OVERALL SITE PLAN  
SCALE: 1"=80'

**RECORD DRAWING**  
RECORD DRAWING INFORMATION IS PROVIDED BY PEASE & SONS, INC ON 05-04-2022. RECORD DRAWING INFORMATION WAS REVIEWED BY R. HAND OF SITTS & HILL ENGINEERS AND THE INSTALLATION SUBSTANTIALLY CONFORMS TO THE APPROVED PLANS. RECORD DRAWING CHANGES ARE ON THE CAD FILES SUBMITTED WITH THIS DOCUMENT.

**BCRA**  
PROJECT: FOR PUYALLUP SCHOOL DISTRICT  
**KESSLER CENTER**  
1501 39TH AVENUE SOUTHWEST  
PUYALLUP, WA 98373

**COP#5 - SHEET C1.1 - DEMOLITION AND EROSION CONTROL PLAN - STAGE A**

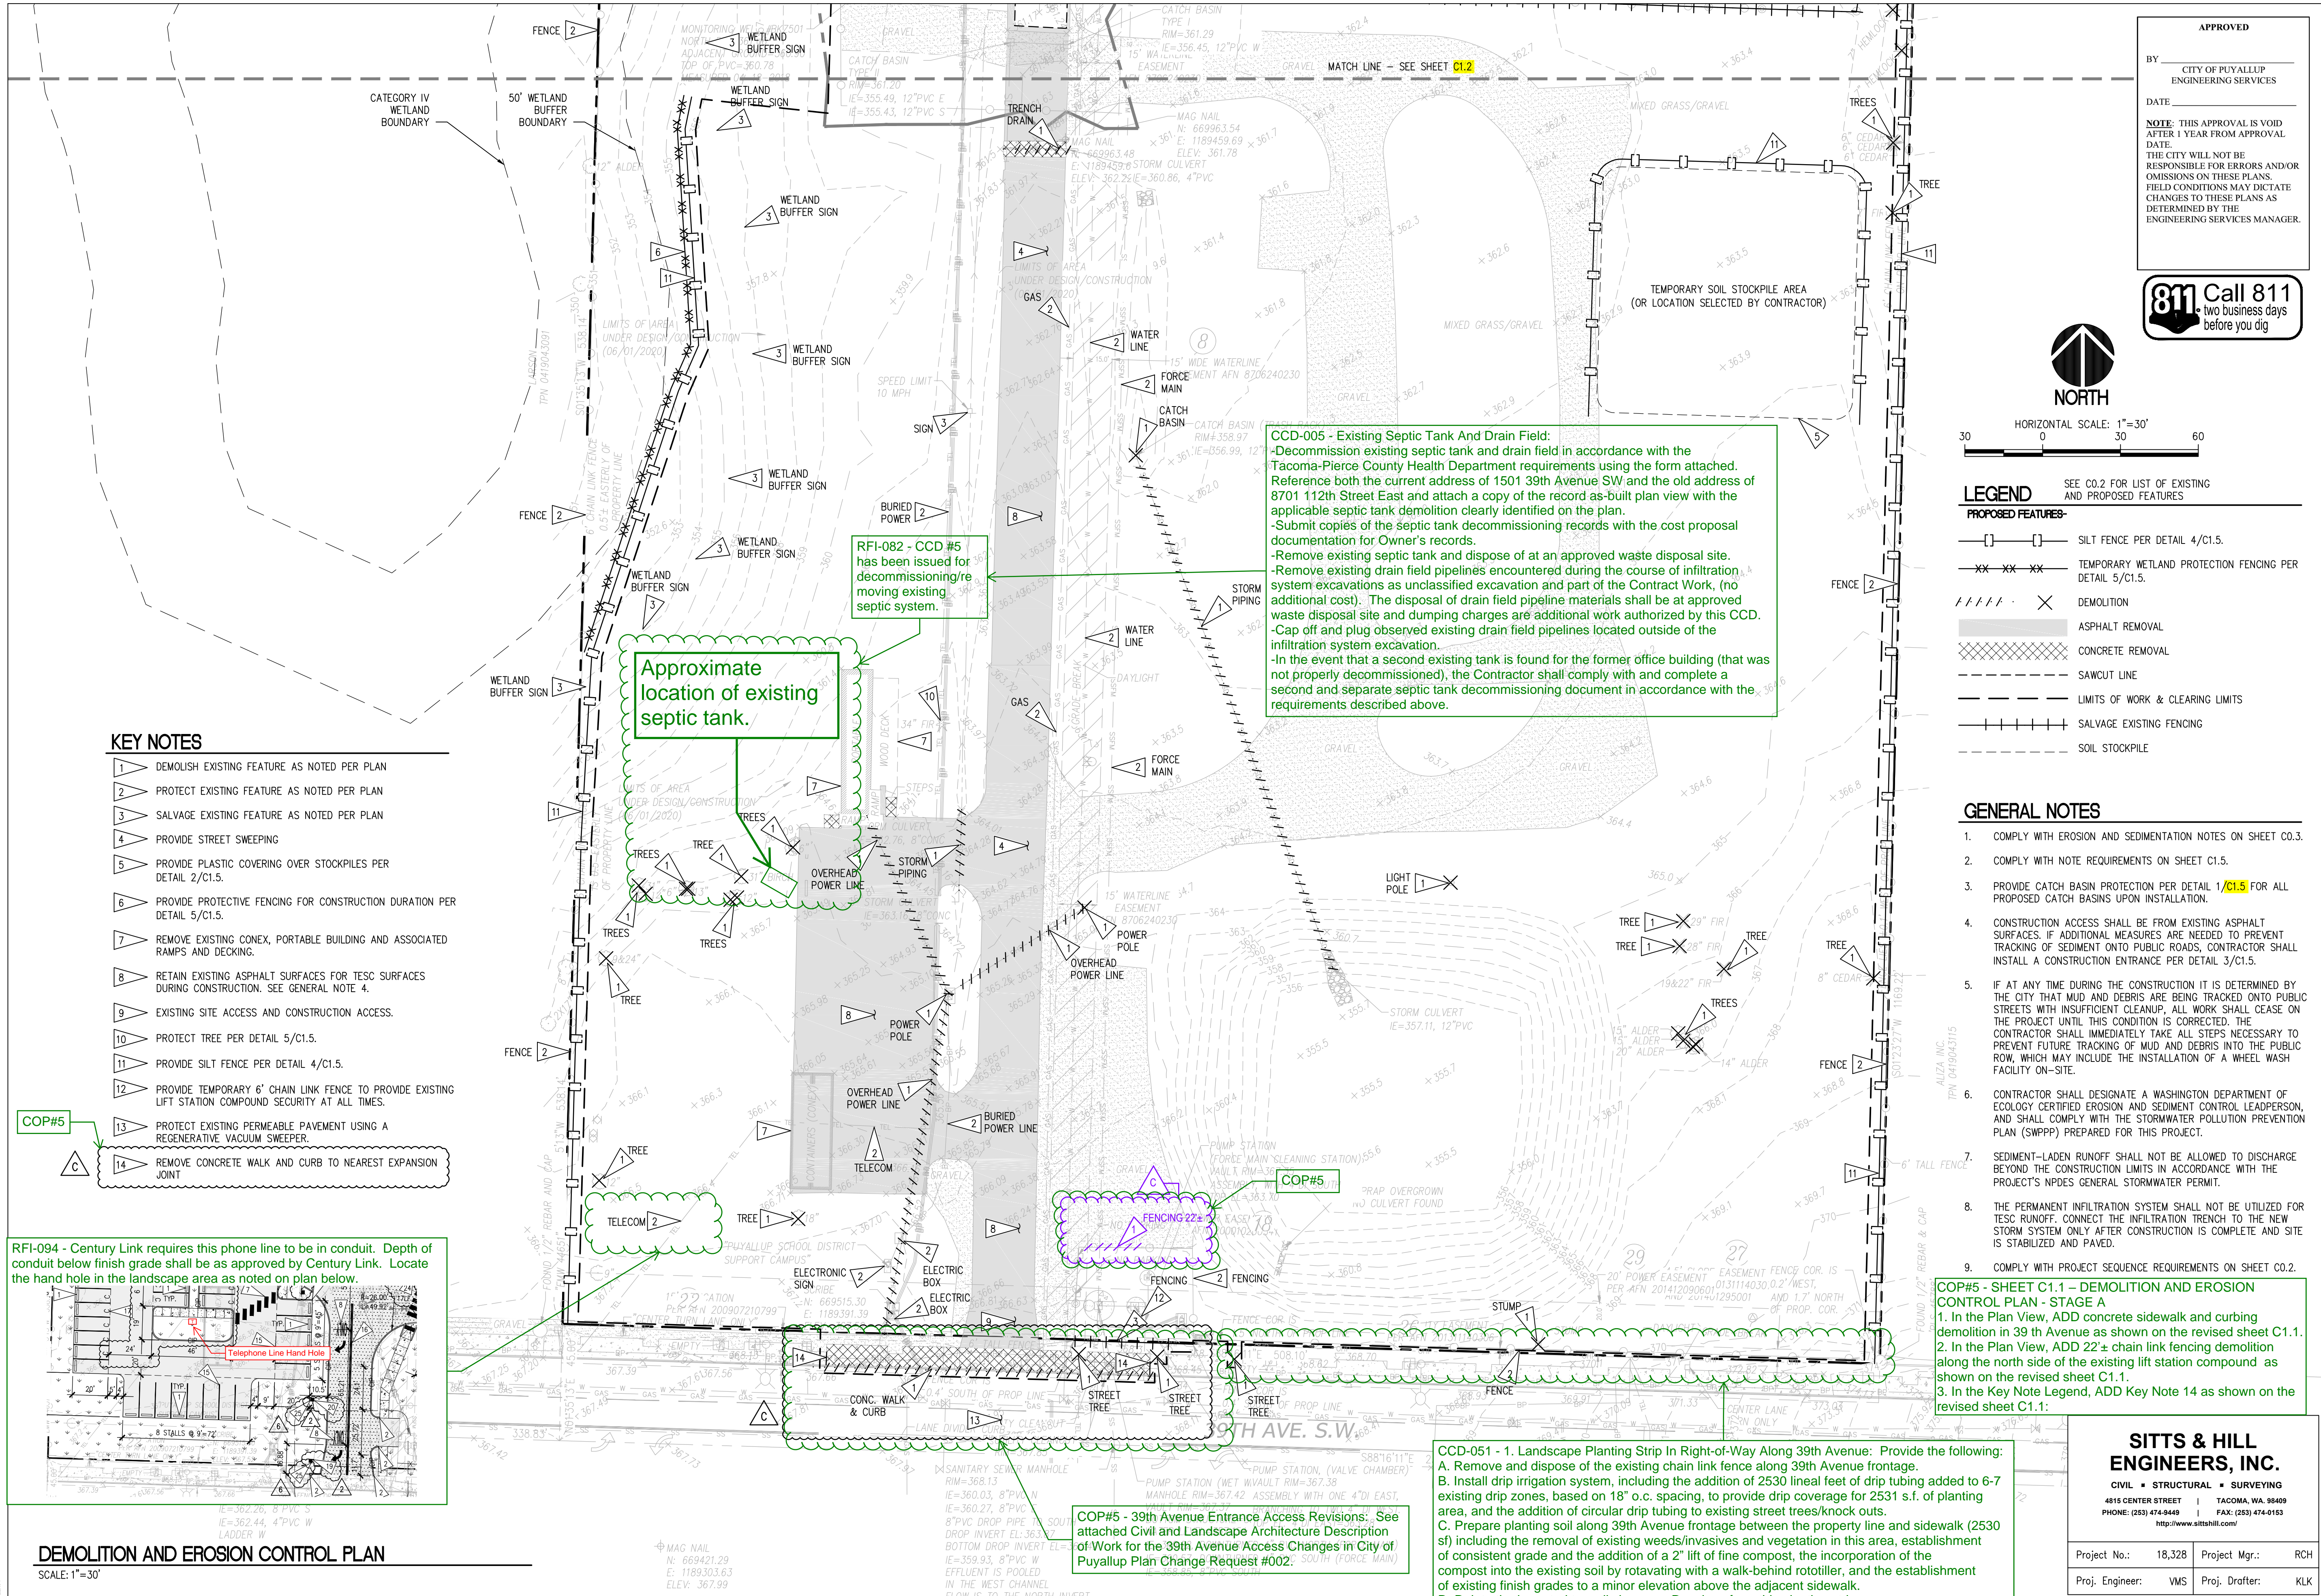
- In the Plan View, ADD concrete sidewalk and curbing demolition in 39th Avenue as shown on the revised sheet C1.1.
- In the Plan View, ADD 22'± chain link fencing demolition along the north side of the existing lift station compound as shown on the revised sheet C1.1.
- In the Key Note Legend, ADD Key Note 14 as shown on the revised sheet C1.1:

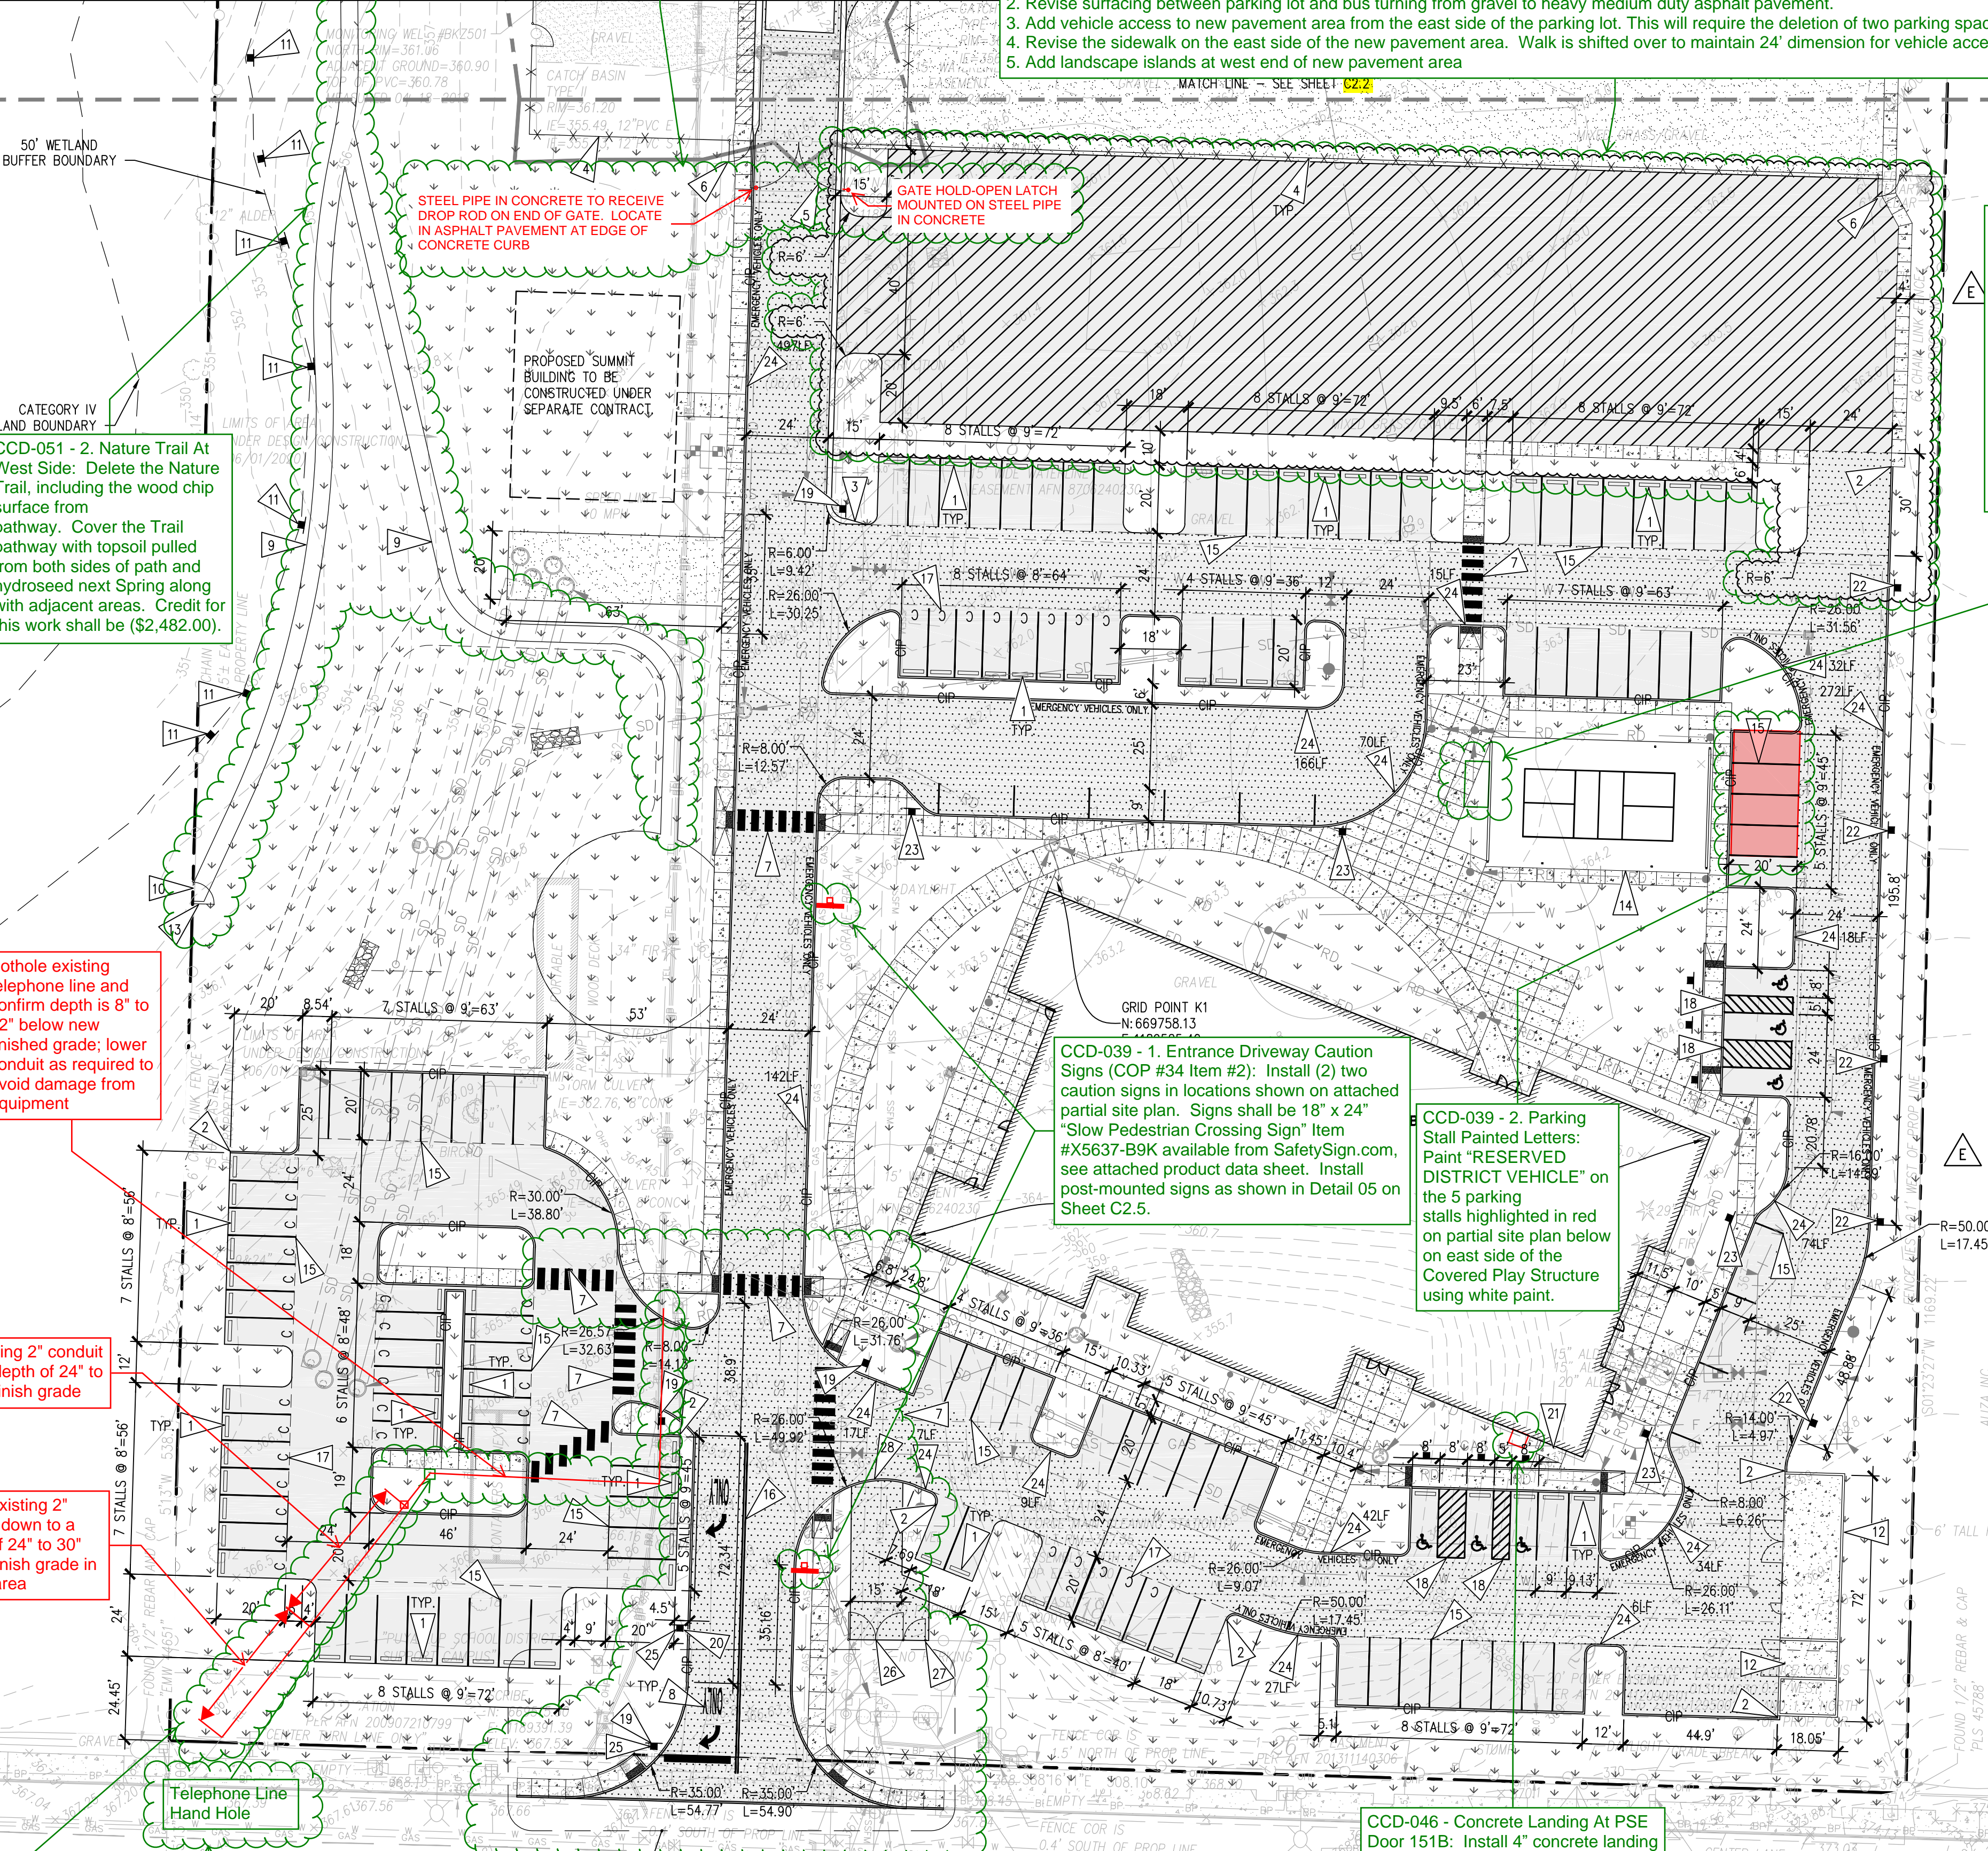
CCD-042 - 2. Hold-Open Latches On Entrance Drive Gate: Install means to hold gate leaves open as shown on attached partial Surfacing Plan C2.1.

CCD-025 - COP #28R: Proceed with the overflow parking area revisions outlined in COP #28R. Overflow Parking Area Revisions: This COP revises the hydroseeded overflow parking area to be paved with asphalt paving; revise as follows: Sheet C2.1.  
 1. Replace Sheet C2.1 with revised Sheet C2.1 attached;  
 2. Revise surfacing between parking lot and bus turning from gravel to heavy medium duty asphalt pavement.  
 3. Add vehicle access to new pavement area from the east side of the parking lot. This will require the deletion of two parking spaces and an asphalt wedge curb.  
 4. Revise the sidewalk on the east side of the new pavement area. Walk is shifted over to maintain 24' dimension for vehicle access.  
 5. Add landscape islands at west end of new pavement area

RFI-296 - Storage shed top of floor slab elevation shall be at 363.0416 and should be about 1/2" above the concrete walkway elevation of 363.00 contour line shown on Sheet C3.1 at the door on north side; field verify and coordinate with concrete walkway. Concrete walkway slopes down from this doorway to the north. Set concrete walkway at door threshold 1/4" below top of floor elevation in storage shed to accommodate the threshold configuration.

RFI-292 - 1. Confirmed, the slab on grade reinforcing should be #4 at 18" on center each way. 2. The #5 vertical bars are to be per the attached sketch.

CCD-017 - COP #27 - Storage Room Addition On Covered Sport Court: Proceed with the work of COP #27. Landscape Drawings L-101, L-201, L-301, L-304, L-401 are added for landscape work clarity at this Storage Room. Top of floor slab elevation in Storage Room shall be 1/4" higher than concrete pavement elevation shown on Civil Drawings at door location on north side.

CCD-039 - 1. Entrance Driveway Caution Signs (COP #34 Item #2): Install (2) two caution signs in locations shown on attached partial site plan. Signs shall be 18" x 24" "Slow Pedestrian Crossing Sign" Item #X5637-B9K available from SafetySign.com, see attached product data sheet. Install post-mounted signs as shown in Detail 05 on Sheet C2.5.

**CCD-014 - Sidewalk Revision:** Revise location of concrete sidewalk as shown on Sheet C2.2 attached.

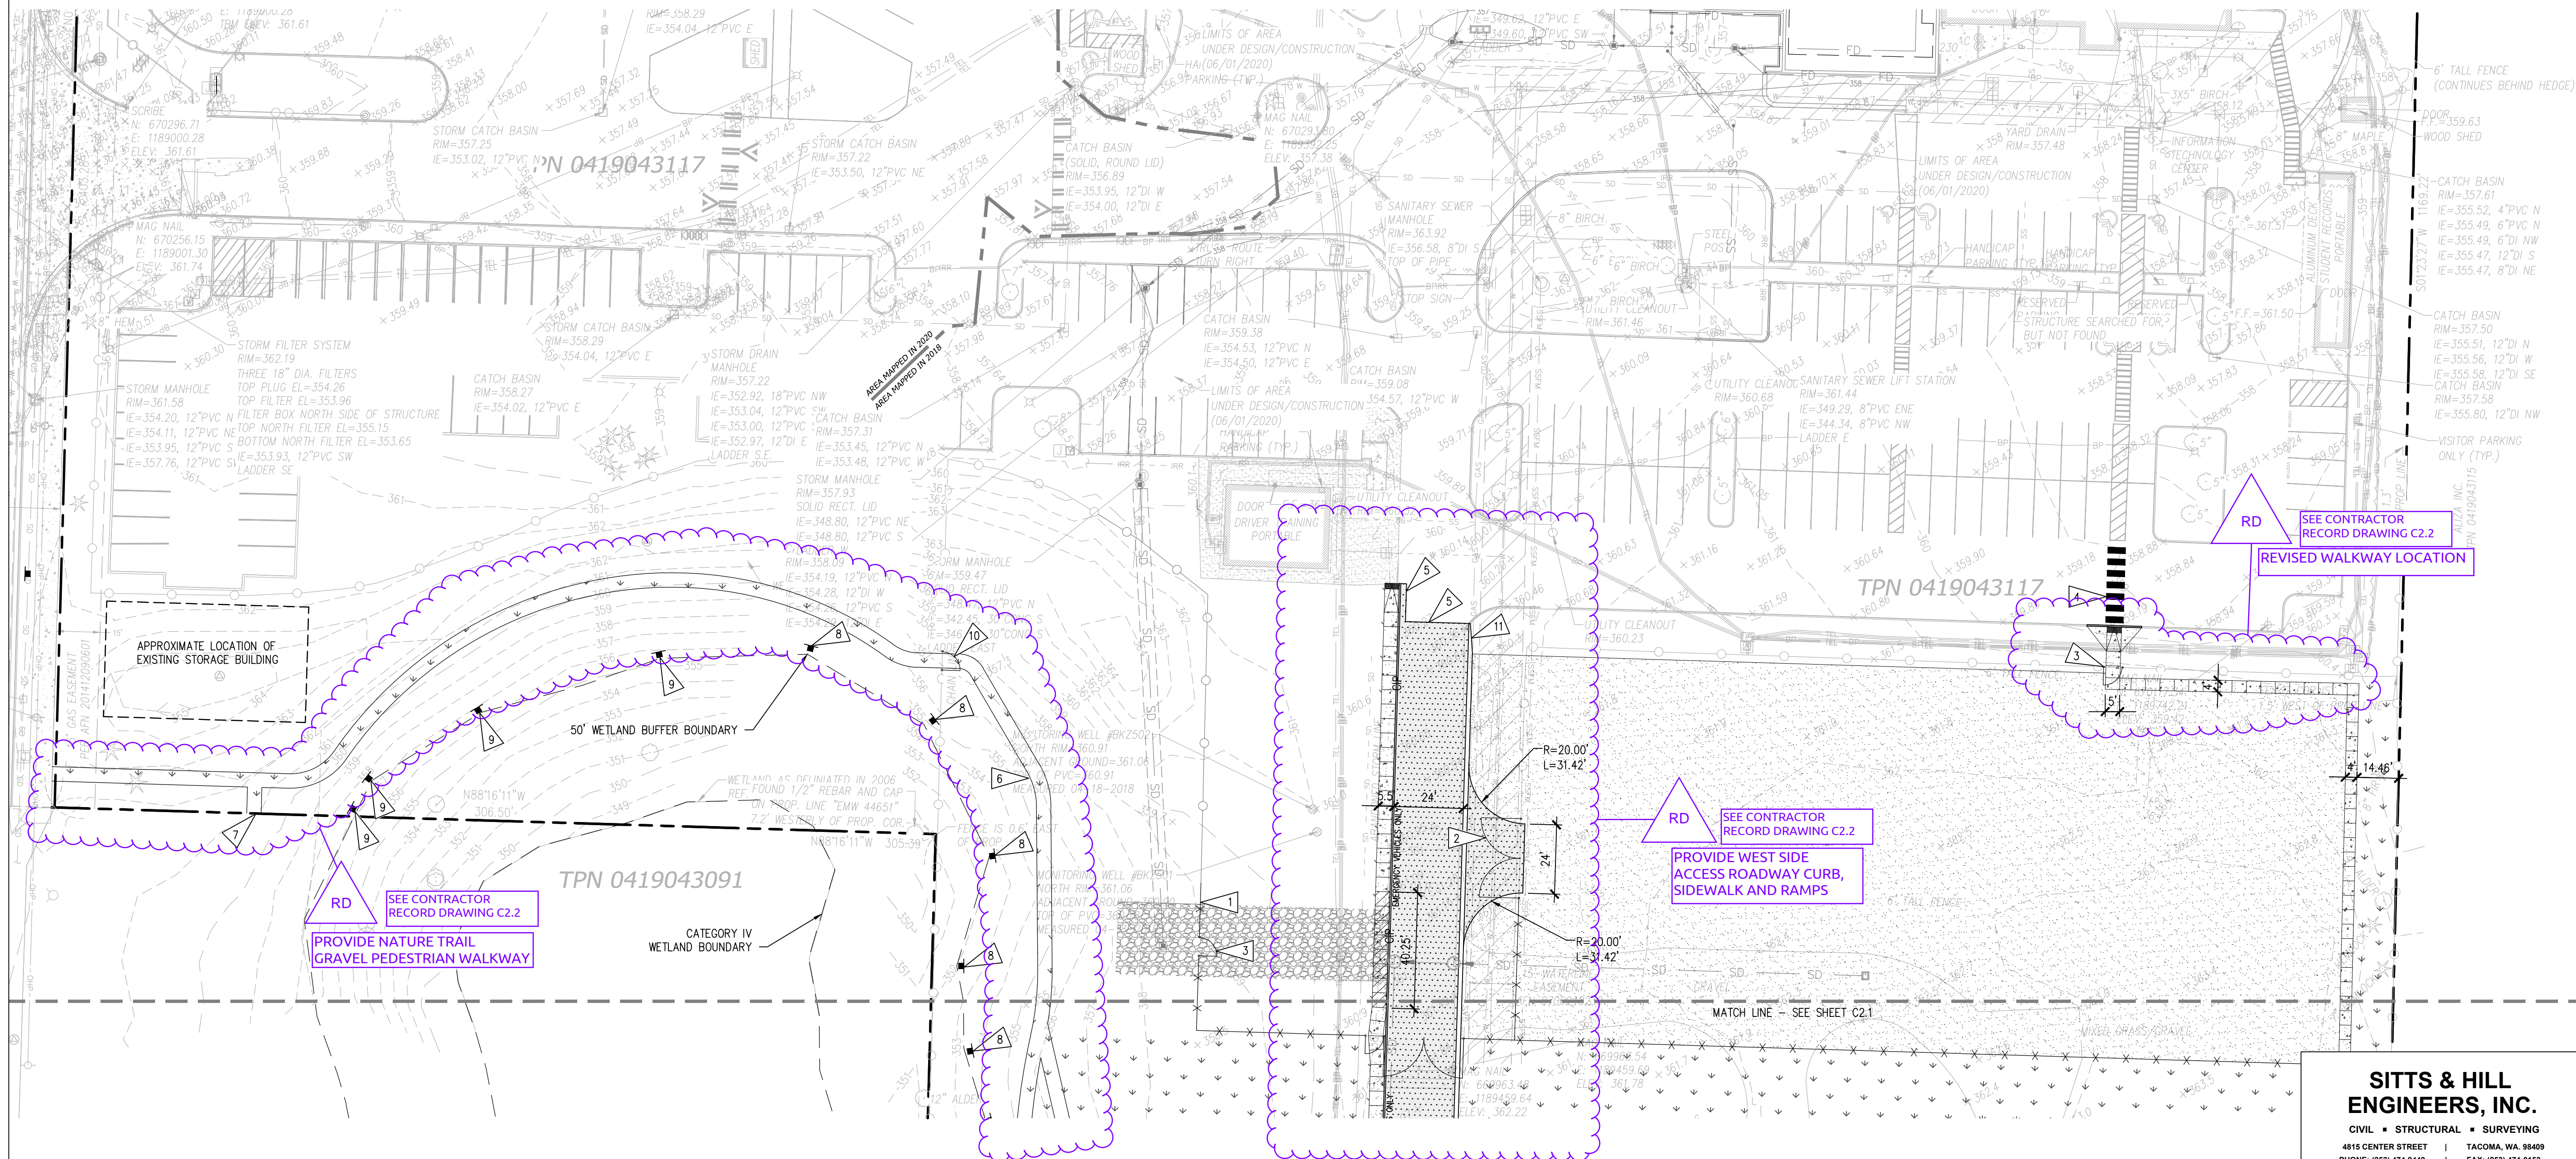
- Delete asphalt pavement on entrance road already installed previously by Owner; refer to attached Sheet C2.2 for location and extent.
- Revise standard sidewalk on west side of entrance road to thickened sidewalk with rolled curb; refer to attached Drawings for location and extent.
- Construct ADA accessible ramp at north end of sidewalk as noted on attached Drawings.
- Add sidewalk on west side of entrance road alongside the existing bus driver's portable as noted on attached Drawings.
